# Service Bulletin

| Bulletin No. | 2010-10 |

# Correction to Fuel Pressure Specification Table in Service Manual #31

## **Specifications**

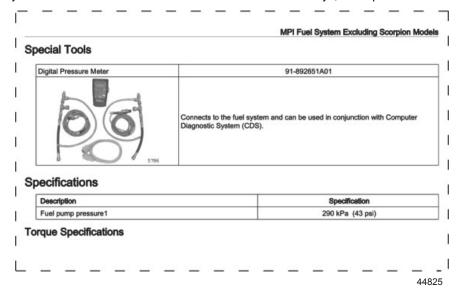
In Section 5 of Service Manual #31 (90-864260300), the fuel pressure for MPI fuel systems (excluding Scorpion models) is displayed incorrectly in the specifications table on page 5C-3 as 207 kPa (30 psi).

The correct fuel pressure for MPI fuel systems (excluding Scorpion models) is 290 kPa (43 psi). Using the enclosed adhesive overlay, apply the revised fuel pressure specification table to page 5C-3 of Service Manual #31.

| Description        | Specification    |
|--------------------|------------------|
| Fuel pump pressure | 290 kPa (43 psi) |

One overlay is inlcuded with this kit. To install the overlay, peel it from the backing and place it over the corresponding section on page 5C-3. One overlay is included with this service bulletin. For additional overlays, order part number 8M0048171.
